THE OVERALL ARCHITECTURAL SCOPE OF THIS PROJECT IS
CONSTRUCT ONE COMMERCIAL SHELL BUILDING WITH 3 FUTURE
TENANTS AND RELATED SITE DEVELOPMENT.

Shell Permit Only. Separate Tenant Improvement Permit will be required prior to Occupancy.

EAST TOWN CROSSING
COMMERCIAL LOT 1
727 SHAW ROAD PUYALLUP WA

AGENCY REVIEW - REVISION #1 | 25.07.16

SHEET NO.
P2.00

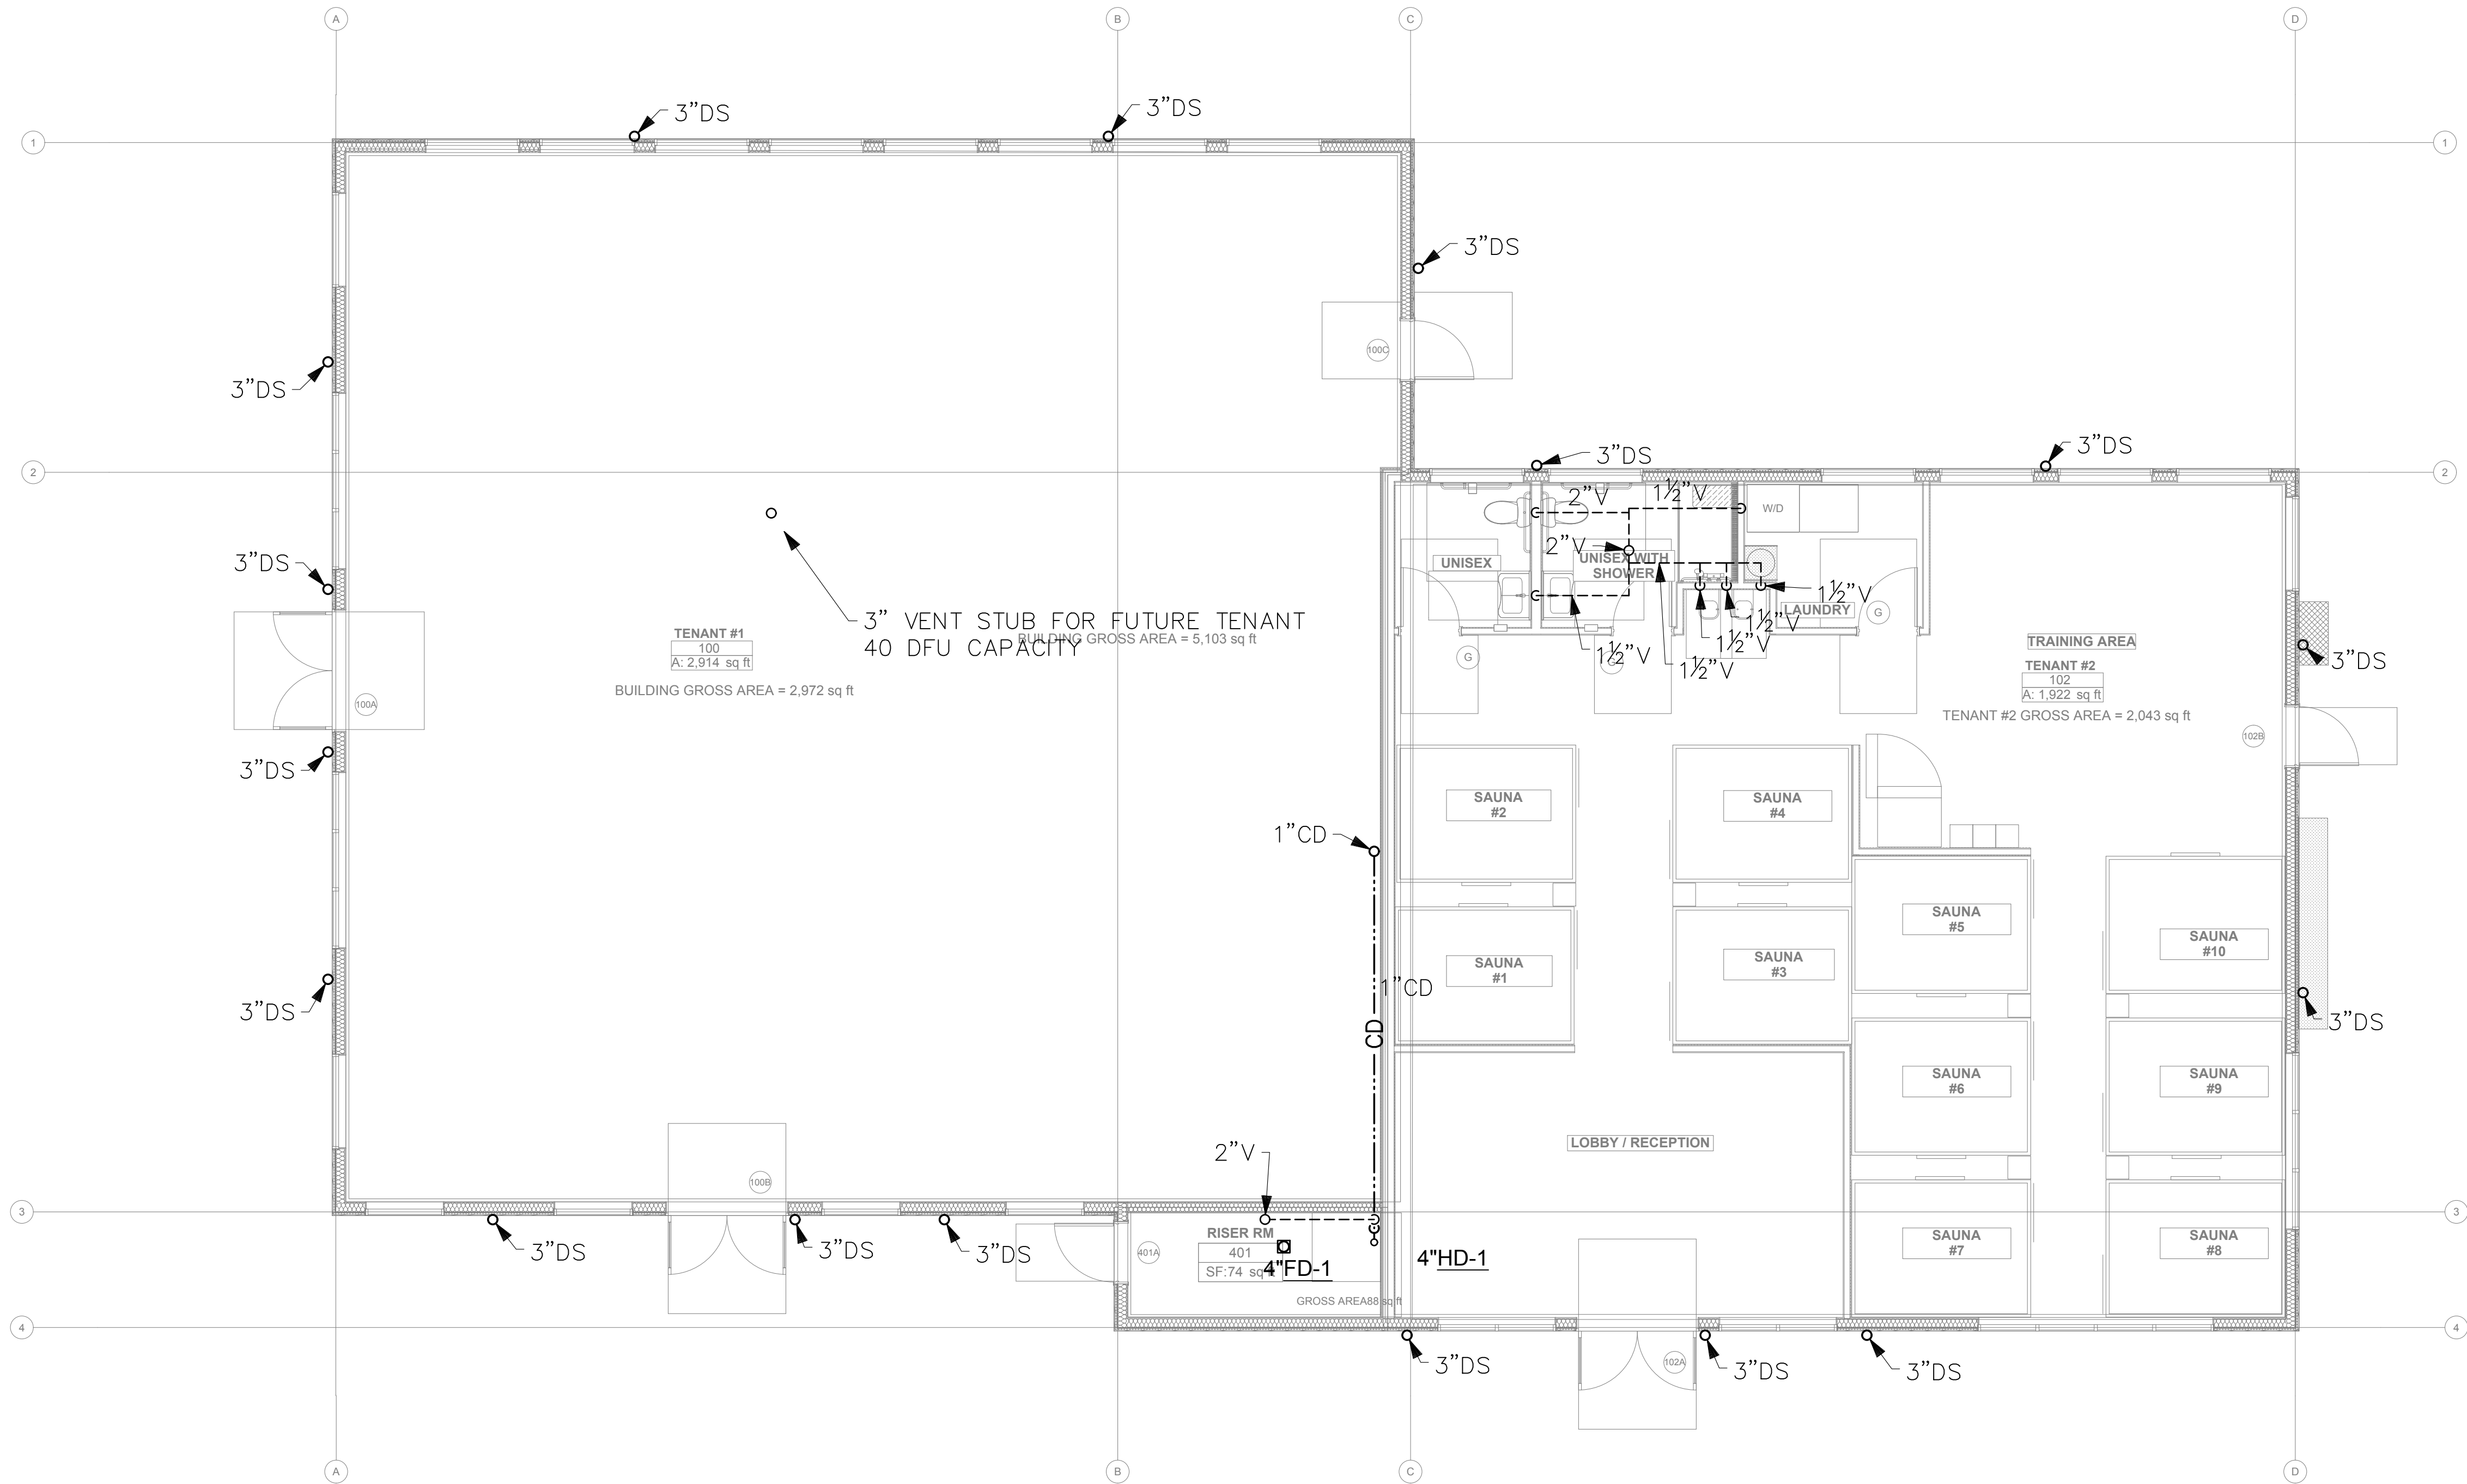
The gravity grease interceptor sizing shall comply with UPC Section and Table 1014.3.6. If each tenant has 20 DFUs as labeled on sheet P2.00, a minimum 1,250 gallon grease interceptor is need, so the 1,588 gallon interceptor listed herein would be adequately sized.
